MEMORANDUM

SUBJECT: Zoning Compliance Analysis, Ward 1 Emergency Shelter

DATE: April 18, 2019

ZONING SUMMARY

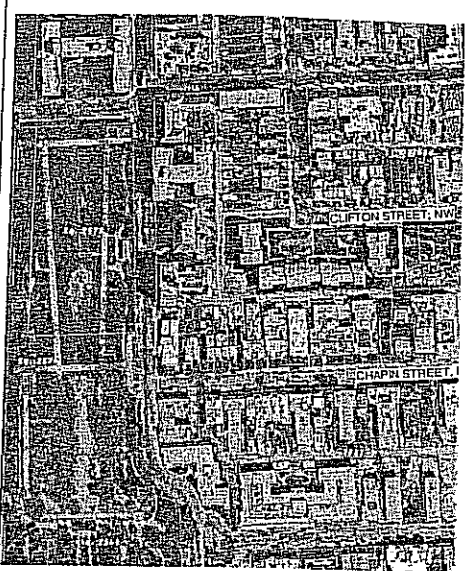
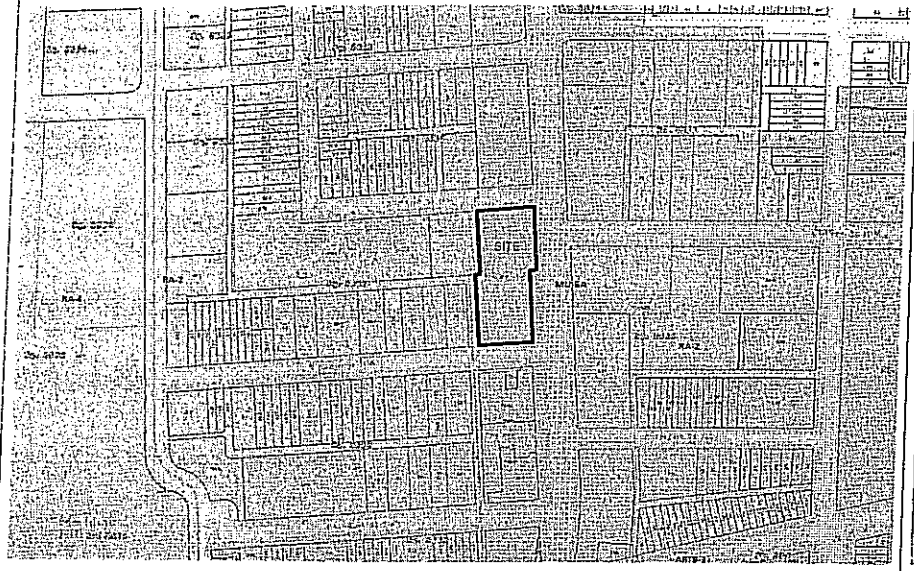
You have asked me to review the plans submitted by the Department of General Services (DGS) for permitting of the Ward 1 Short Term Family Housing Facility (the "Plans"). This is essentially a review of the ZONING SUMMARY table ("Table") set out on Plan Sheet No. A0.11. A copy of the Table is attached for your reference. As detailed below, notwithstanding the Table's purported compliance with the Zoning Regulations, I find a number of significant deficiencies in the conclusions expressed in the Table. The Plans should not be approved in their present form, and are subject to challenge if they are approved.

Height. The Table shows compliance with the 65’ height limit for buildings not employing inclusionary zoning in the MU-5A zone, as set forth in G-403.1. I see no compliance issue here, regardless of the multiple uses.

FAR. The FAR for the Property, at 41,099 sq. ft., is $3.5 \times 41,099 = 143,846$ sq. ft., without inclusionary zoning. G-402.1. The Table reports the combined building gross floor area as 82,709 sq. ft., of which 67,630 will be the new addition, i.e., over 80%. I have not investigated whether the claimed deductions from gross floor area are justified, in that the reported gross floor area is nowhere near the allowed limit for the MU-5A zone.

Setbacks. The Table reports that no front, rear or side yard setbacks will be provided. There is no front yard setback requirement in the MU-5A zone. Under G-406.1, there is no side yard setback requirement. But this provision states that if a side yard is provided, it should be at least 10.83 feet in width (2” for each foot of the building’s 65’ height). As for the rear yard, purportedly facing Chapin Street, N.W., the Table states that none is required because the Property is a “through lot,” citing B-317.3. This is incorrect. The Property is not a “through lot,” because the Property is a “corner lot” under the lot definitions in the Zoning Regulations. B-100.2. The Property is also a corner lot that abuts three streets. Ignoring for the moment the improper single-building determination, the required rear yard—in this case 15 feet, G-405.2—is to be measured from the center line of Chapin Street, N.W. to the wall of the community center building. This measurement is not provided in the Table, but other plans reveal that the setback requirement is met. See Plan Sheet CIV0105.

Parking. The Table erroneously claims parking compliance by ignoring the fact that parking requirements are different for the two uses being added to the Property. For the residential apartments, the Table reports the requirement to be one space for every dwelling unit in excess of four. C-701.5. With 15 units, the excess is 11 units, which translates to 3.6 spaces, which is rounded up to 4. C-709.3. For the emergency shelter, the requirement is not noted in the Table, but it is .5 spaces for each 1000 sq. ft. of the shelter. *Id.* In this case, there is no overall allocation of space as between the two uses, but a reasonable estimate of the amount can be derived from the ratio of shelter units to all units, or $35:50 = 70\%$. Multiplying that ratio times the overall gross floor area of 67,630 sq. ft. = 47,341 sq. ft., which translates to $.5 \times 47.3 = 23.67$ spaces, rounded up to 24. Thus, the total parking requirement for the two uses, if one rounds numbers after adding, would be $3.6 + 23.67 = 27.27$ spaces, which would be rounded down to 27 spaces, if not 28 by rounding earlier.⁶ The Table also claims that the parking requirement is halved under C-702.1.c.3., in that the Property is within a quarter mile of the 16th Street bus corridor. If that is correct,⁷ then the parking requirement would be 14 spaces, whereas the Table states that only 8 spaces are provided. That is also the number of spaces depicted on Sheet A2.00, the P1 Floor Plan. The Narrative inconsistently states that 9-12 spaces will be provided, but that none of them will be for shelter residents. In either case, there is a parking shortfall.

Loading. The Table claims that no loading space is required and that none is provided, citing C-901.1. This is correct as to the community center, which is under 30,000 sq. ft., and as to the residential units, which at 15 are under the 50-unit exemption for residential buildings. But the loading requirement for an emergency shelter is one when, as here, the size of the shelter is between 30,000 and 100,000 sq. ft. of gross floor area. This is another case where, as with parking, DGS has failed to draw the proper use-based distinction in complying with the development standards.

The applicable provision is C-802. Under C-802.10, the number of spaces must at least equal the total required for all uses. For the residential use, the requirement is 1 long-term space for each 3 units, and 1 short-term space for each 20 units. At 15 units, that would be 5 long-term spaces and 1 short-term space. For the shelter, the requirement is 1 space for every 10,000 sq. ft., for each type of space. Using the above 47,341 estimate of the gross floor area, this translates to 4.73 spaces of each type, rounded up to 5. For the Community Center, there is no long-term space requirement, but a minimum of 6 short-term spaces. Hence the total number of long-term spaces required is $5 + 5 = 10$ spaces; the total number of short-term spaces required is $1 + 5 + 6 = 12$. The Table thus claims compliance as to the long-term requirement (17 provided/10 required), and non-compliance as to the short-term requirement (3 provided/12 required). Again, failure to distinguish one use from another infects the demonstration of compliance, but whatever the allocation of space between the two uses in the new building proves to be, there will be a shortfall in bicycle parking.
